METROPOLITAN GOVERNMENT OF NASHVILLE AND DAVIDSON COUNTY

STAFF RECOMMENDATION
1409 Sumner Avenue
August 20, 2014

Application: New construction--infill
District: Eastwood Neighborhood Conservation Zoning Overlay
Council District: 06
Map and Parcel Number: 08305045100
Applicant: Van Pond, Jr.
Project Lead: Paul Hoffman, paul.hoffman@nashville.gov

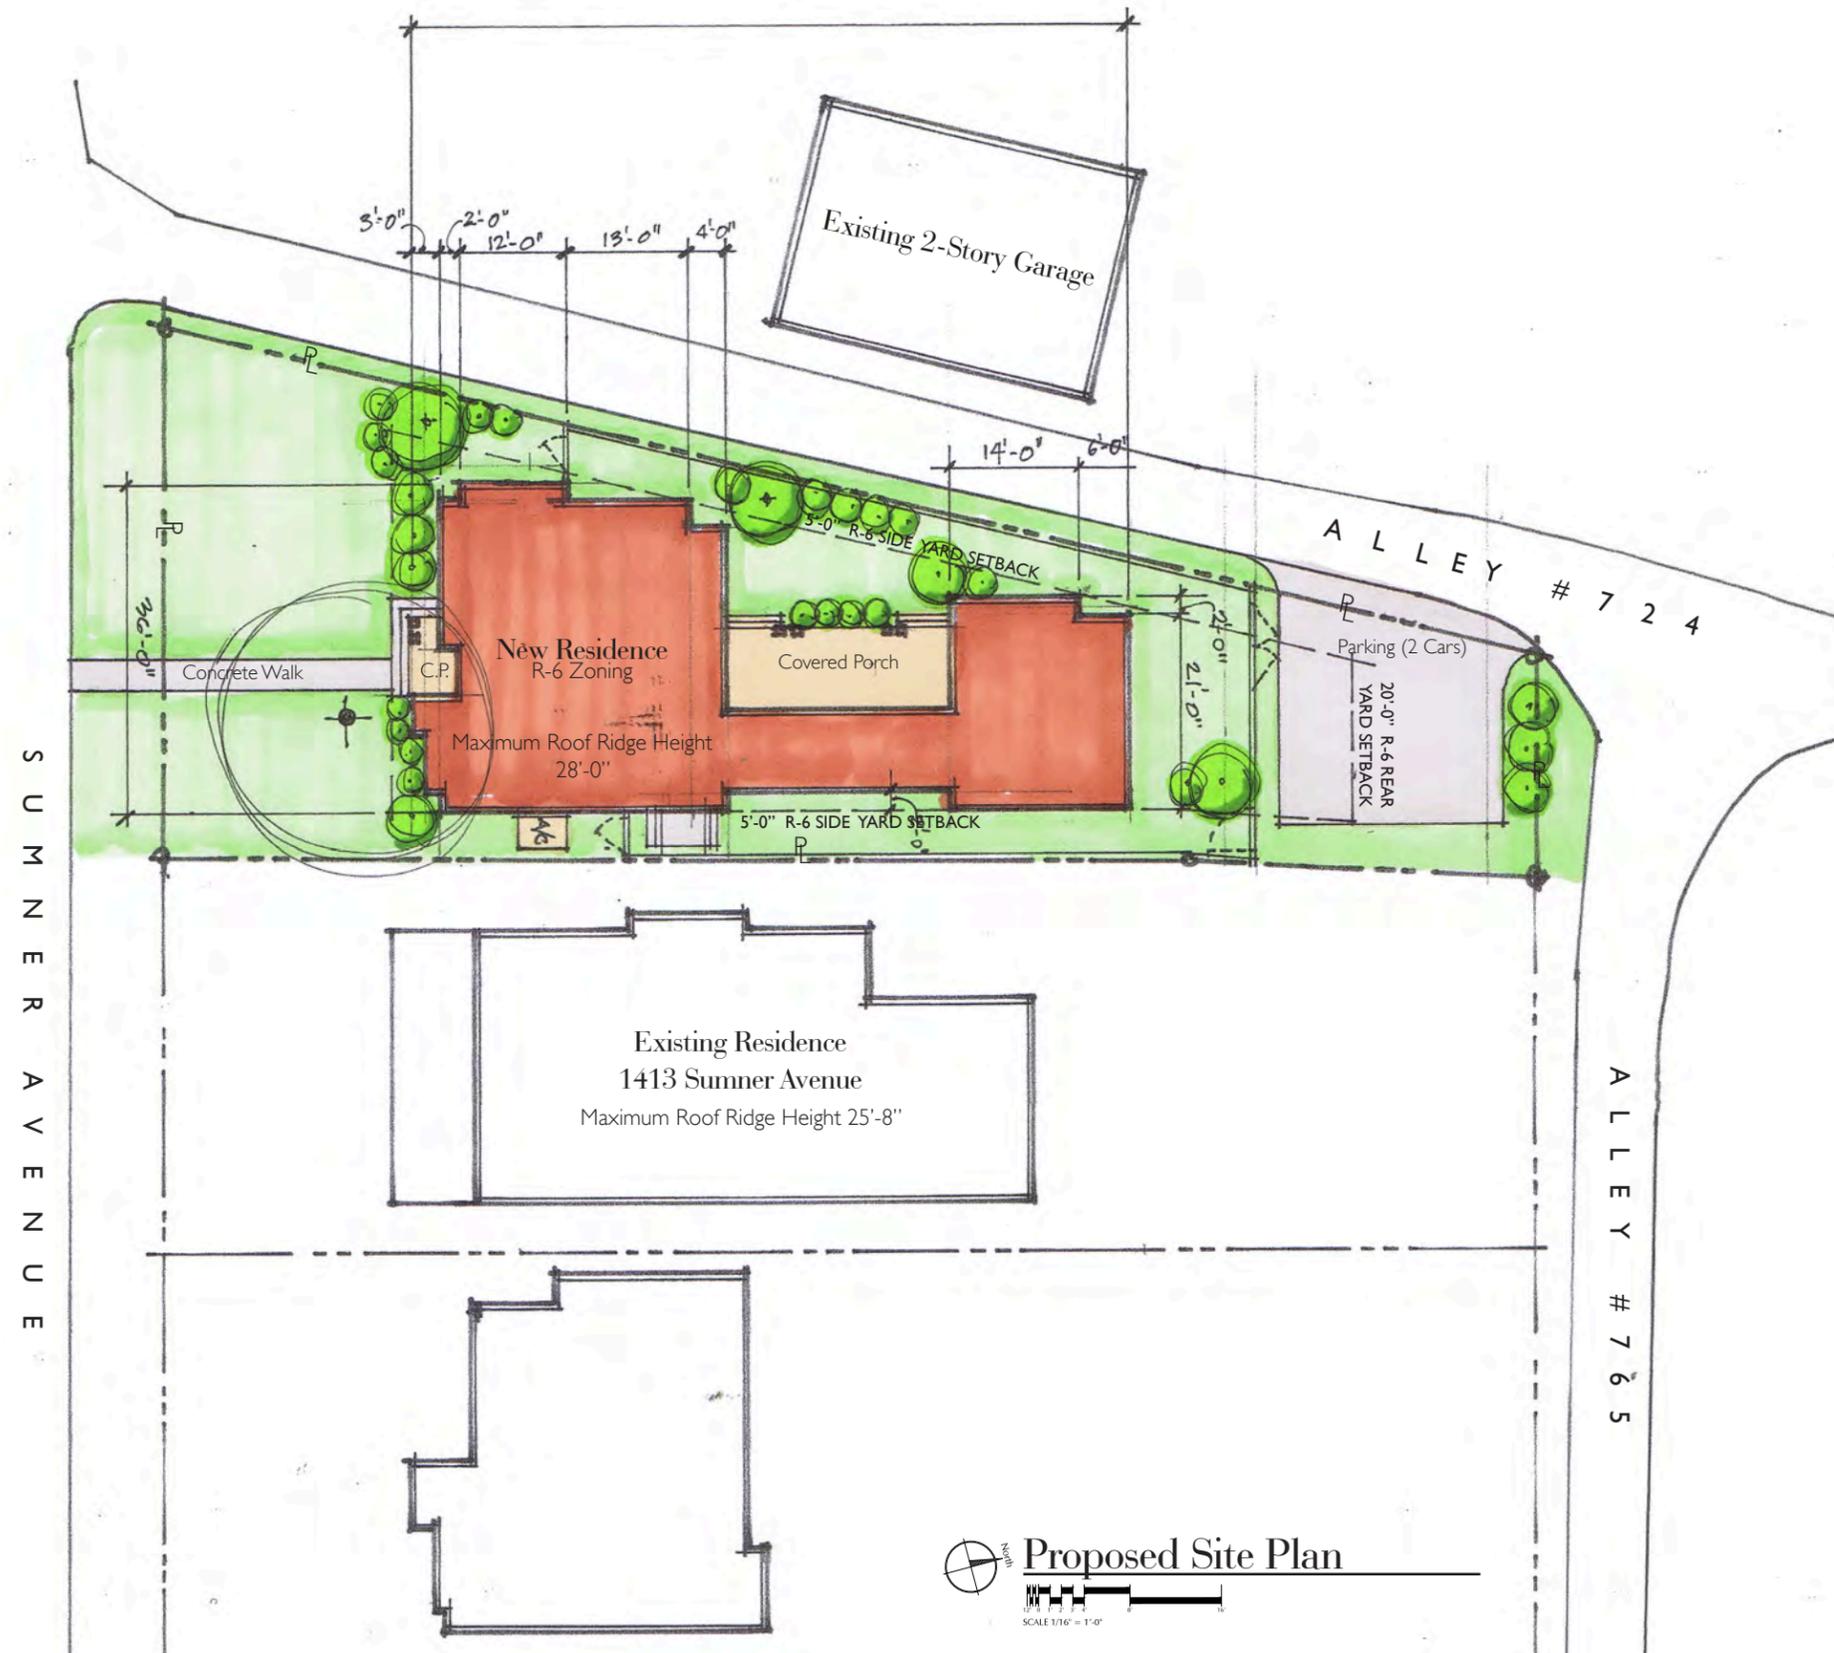
Setback & Rhythm of Spacing: The house will be centered on the lot, meeting the required five foot (5') setback on each side. Its front setback of twenty feet (20') is in line with the adjacent buildings. Rear setback is thirty-five feet (35') from the rear property line. A right stoop projects into the setback area, which is allowed by Code. The project meets zoning requirements and section II.B.1.c of the design guidelines.

Appurtenances & Utilities: The current drawings indicate the HVAC unit located toward the front of the house's right side; the architect has agreed to move the HVAC to the rear façade, or on a side façade beyond the midpoint of the house. The project meets section II.B.1. i.

1. Staff approve the final details, dimensions and materials of windows and doors prior to purchase and installation;
2. Staff approve the roof color and masonry color, dimensions and texture;
3. The finished floor height shall be consistent with the finished floor heights of the adjacent historic houses, to be verified by MHZC staff in the field; and,
4. The HVAC shall be located behind the house or on either side, beyond the mid-point of the house.

Proposed North Elevation

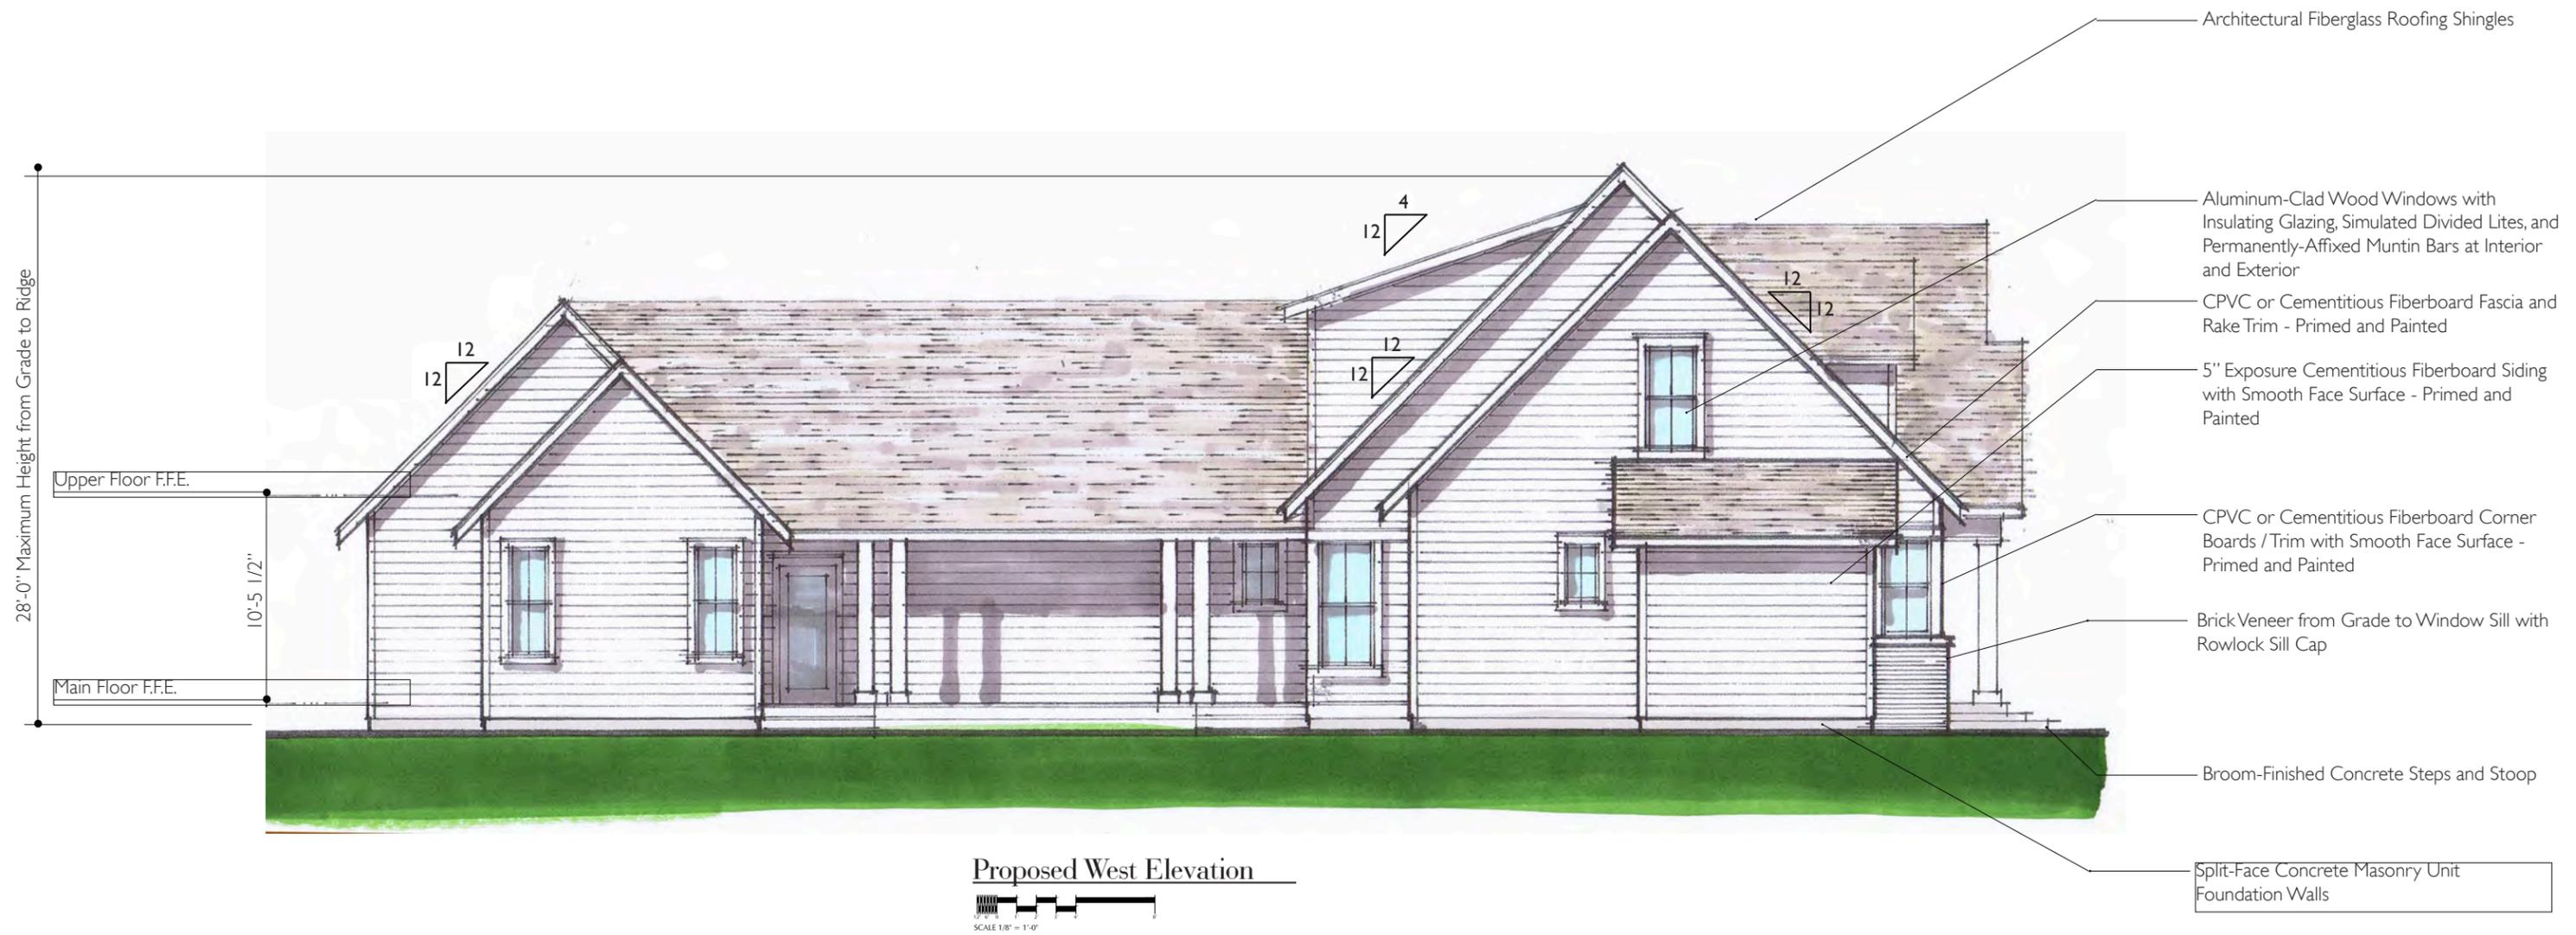
Roof form: The house has a side-gabled section at both the front and rear with a gabled connection between. Primary roof surfaces have 12/12 pitch. The front of the house has a gabled dormer and porch roof, both with 12/12 pitch. Shed dormers with 4/12 pitch will be on the right and rear roofs. These roof forms and pitches are common in historic districts and meet section II.B.1.e.

Proportion and Rhythm of Openings: The windows proposed are generally twice as tall as they are wide, thereby meeting the historic proportions of openings. The longest expanses without a window or door opening is twenty feet (20') on the west elevation, and sixteen feet (16') on the east side. The west elevation is recessed in the porch on that side and the expanse on the east is at the very back. Staff finds that these areas will be minimally-visible and therefore meet the design guidelines. With this condition, Staff finds the project's proportion and rhythm of openings to meet Section II.B.1.g.
